COMPOSITE FLOOR PLAN

In my review I saw only two issues that staff may wish to explore further.

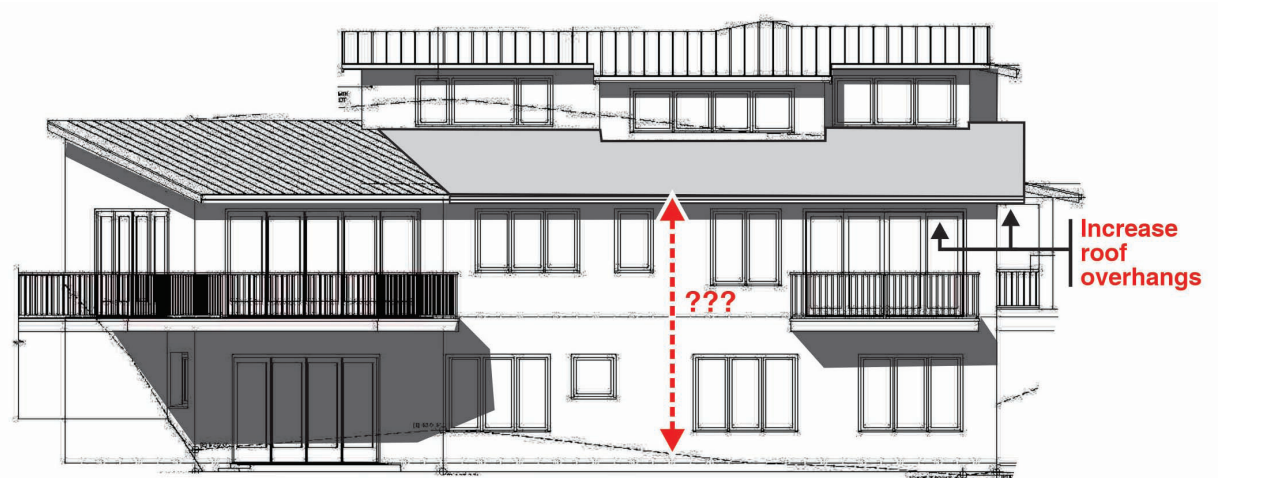
1. The roof overhangs at the second level are smaller than the upper level.
2. There is a portion of the southwest downhill facade that has a two story flat face which would appear to be inconsistent with both the Town's Hillside Development Standards and Design Guidelines and the Town's Single Family Residential Design Guidelines.

Two story wall segment would appear to not be consistent with both the Hillside Design Standards and Guidelines and the Town's Residential Design Guidelines

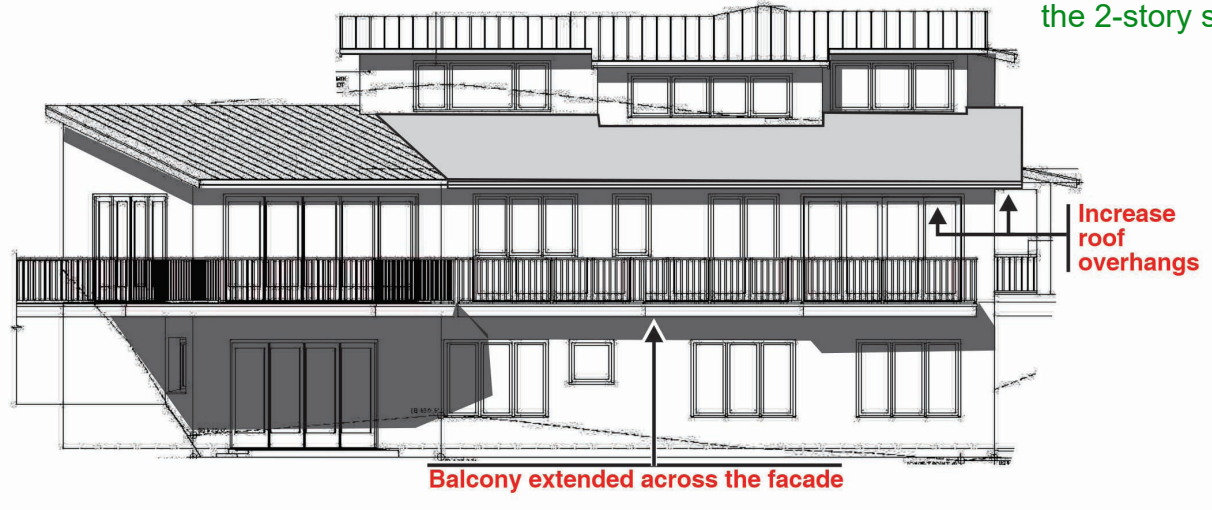
1. Increase the roof overhang to provide a stronger eave shadow line to mitigate the two story facade.
The eaves have been lengthened over the area with the 2-story facade
2. There may be two ways to address the issue of the two story flat downhill facade section:
 - A. Leave it as proposed given the amount of downhill landscaping that is currently a buffer to views from the home below and the applicant's commitment to plant screen landscaping at the lower property line.

- B. Extend the balcony across the facade connecting the currently proposed balcony and deck.
The middle floor has been cantilevered out 18" to between the balconies to break up the 2-story section
